UNITED STATES  
NUCLEAR REGULATORY COMMISSION  
WASHINGTON, D. C. 20555

SUBJECT: CRYSTAL RIVER UNIT 3 - AUDITS ON NRC BULLETIN 88-11, "PRESSURIZER  
SURGE LINE THERMAL STRATIFICATION" (TAC NO. 72172)

AUDIT TRIP HIGHLIGHTS REPORT

AUDIT TRIP REPORT

10" SURGE LINE  
ISOMETRIC  
DRAWING

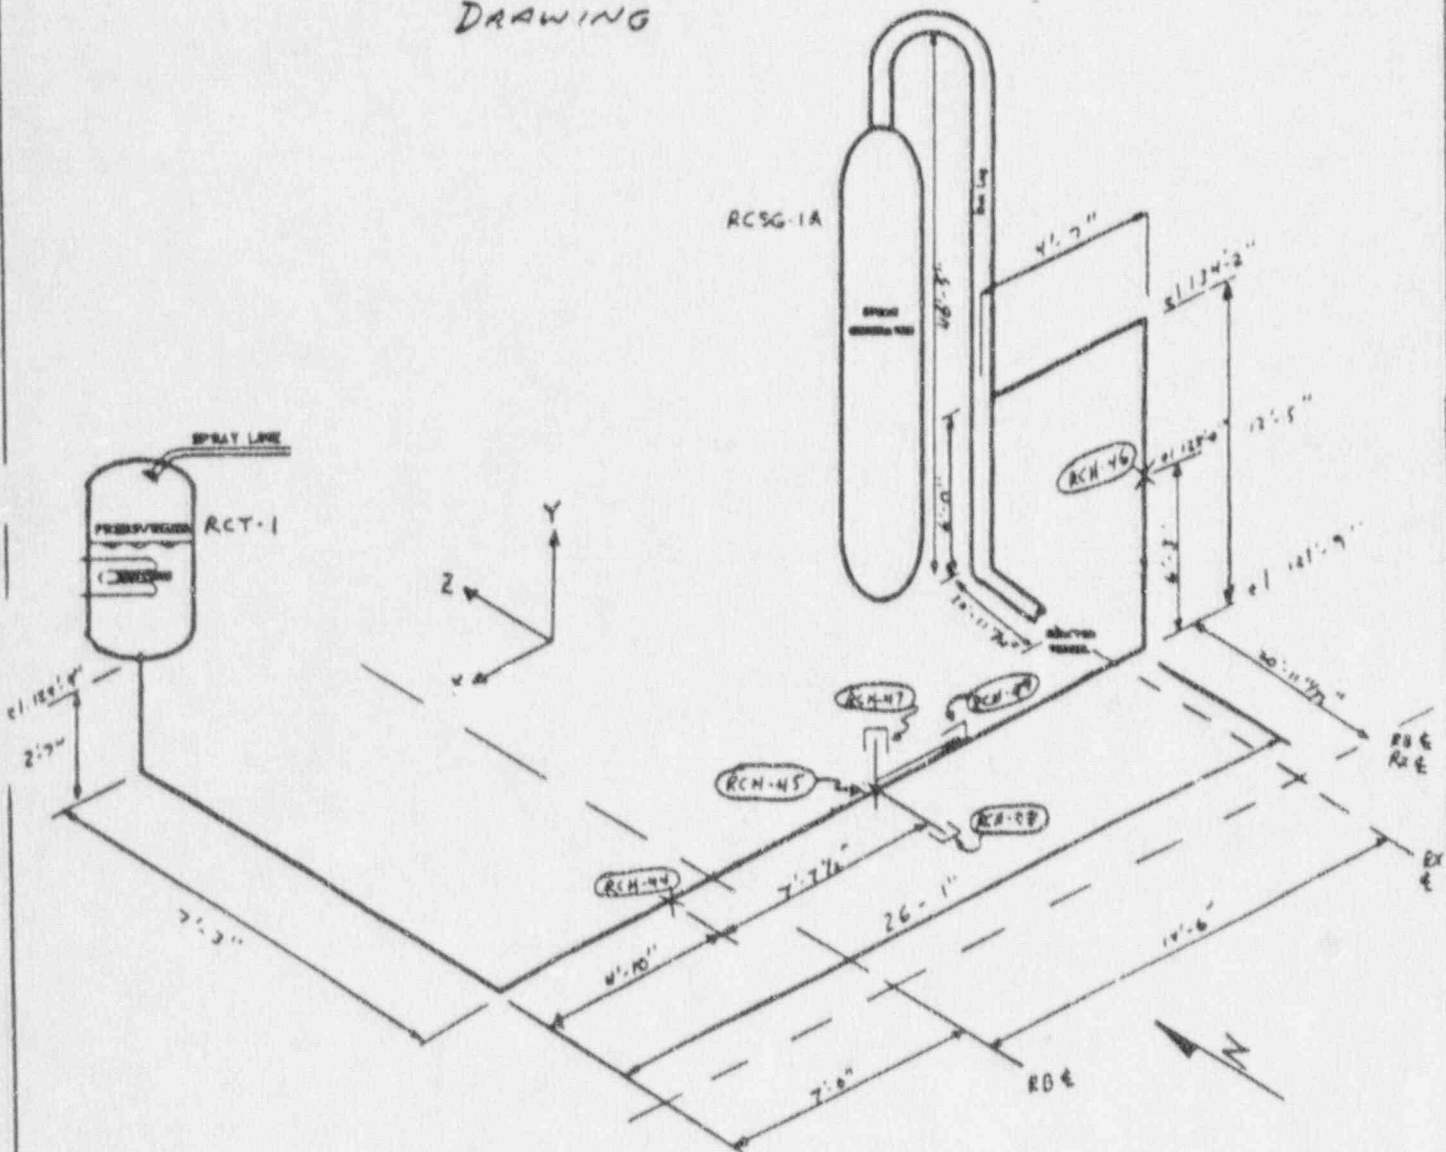
The Licensee provided two drawings of the reactor coolant system which were recently revised to indicate the location of the pressurizer surge line supports. The drawings indicated that the support locations were based on a recent walkdown. A piping isometric drawing was not available but the Licensee provided an isometric sketch which was made up recently (see Attachment 3). However, the original surge line isometric drawing was subsequently found and reviewed by the staff three months after the audit. FPC also provided pipe support drawings for the three spring hangers and three snubbers (see Attachment 3). These drawings were indicated as "as-built" drawings.

The NRC audit team conducted a plant walkdown to inspect the pressurizer surge line. Due to high radiation, access to the area was limited. The team was able to view the line from a platform located about eight feet from pipe support RCH-44. From this area, the horizontal routing of the line and the supports from the pressurizer nozzle to hot leg were visible. The vertical riser and support RCH-46 were behind the hot leg and could not be seen from the observation platform. Although the audit team inspection was limited by distance and pipe insulation, the piping configuration and support arrangement were confirmed and no obvious signs of damage were seen. The audit team also noted that there was adequate vertical clearance to accommodate pipe movement due to thermal stratification. There were no pipe whip restraints or other structures which could interfere with the pipe. Since no pipe whip restraints were seen, the Licensee was asked how the plant is designed for pipe breaks. The licensee couldn't provide an explanation.
